DEVELOPMENT APPLICATION ASSESSMENT REPORT

DA2021/0818

Responsible Officer:	Gareth David
Land to be developed (Address):	Lot 82 DP 23429, 27 Grenfell Avenue NORTH NARRABEEN NSW 2101
Proposed Development:	Alterations and additions to a dwelling house including a secondary dwelling and garage
Zoning:	R2 Low Density Residential
Development Permissible:	Yes
Existing Use Rights:	No
Consent Authority:	Northern Beaches Council
Land and Environment Court Action:	No
Owner:	Jo-Anne Elizabeth Bennett
Applicant:	Jo-Anne Elizabeth Bennett
Application Lodged:	17/06/2021
Integrated Development:	No

Image 1- Building envelope non-compliance (highlighted in green).

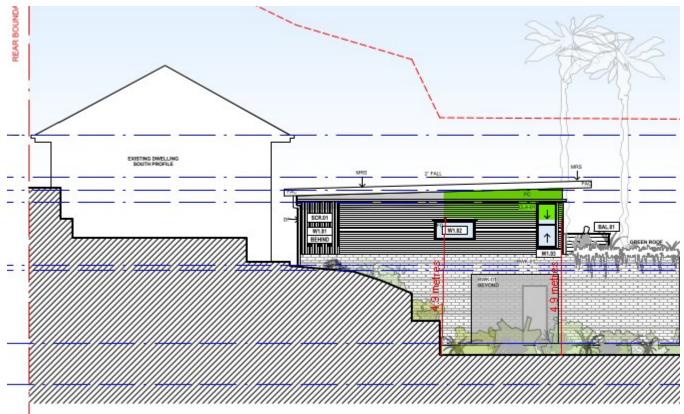
The clause stipulates that buildings are to be projected at 45 degrees from 3.5m above the existing ground level, measured from the side boundaries. The proposed development encroaches into the prescribed building envelope along the southern elevation at a height 1.1m for a length of 4.2m. This can be seen in the image below:
